Southern California Edison Company

Subject: Docket No. 50-206
Heatup and Cooldown Curves
San Onofre Nuclear Generating Station
Unit 1

FIGURE 3.1.3a San Onofre Unit No. 1 Reactor Coolant System Heatup Limitations Applicable for the First 16 EFY.

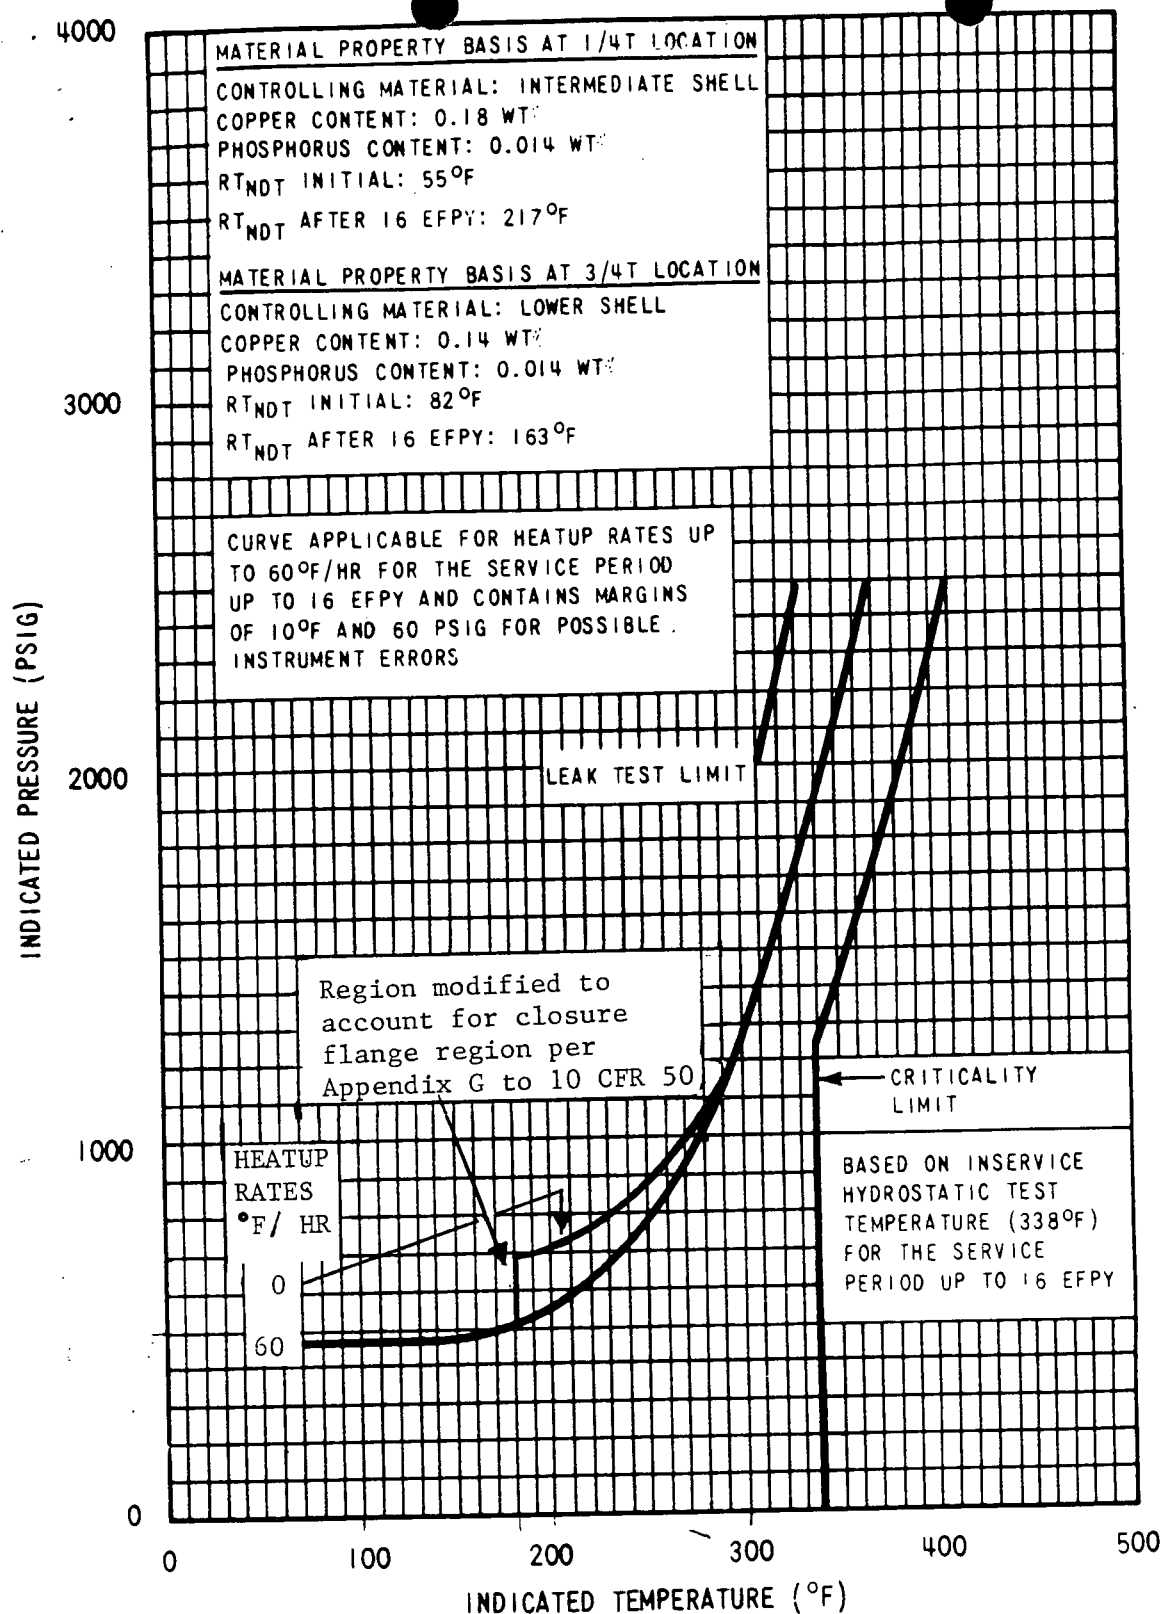
Reference A enclosed SCE Amendment Application No. 118 to revise the Heatup and Cooldown Curves for San Onofre Unit 1. An evaluation of Proposed Change No. 137, enclosed with Application No. 118 was provided via Reference B. The evaluation concluded that results of analysis of Capsule F confirm that the pressure-temperature limits provide sufficient margin to account for neutron irradiation damage through 16 EFPY of operation. However, that evaluation also concluded that further information was required to confirm the safety margins for the closure flange region. Rather than perform the necessary analysis to demonstrate that the closure flange region is not the limiting region for determining the slopes of the heatup and cooldown curves, and because editing the curves to take advantage of the provisions of the current 10 CFR 50 Appendix G for the closure flange region will not affect plant operation, we have decided to modify the curves. The revised curves are provided as an enclosure.

These curves should resolve the concerns with the margins associated with the closure flange region and therefore the additional information requested in Enclosure 2 to the Reference B letter is not necessary.
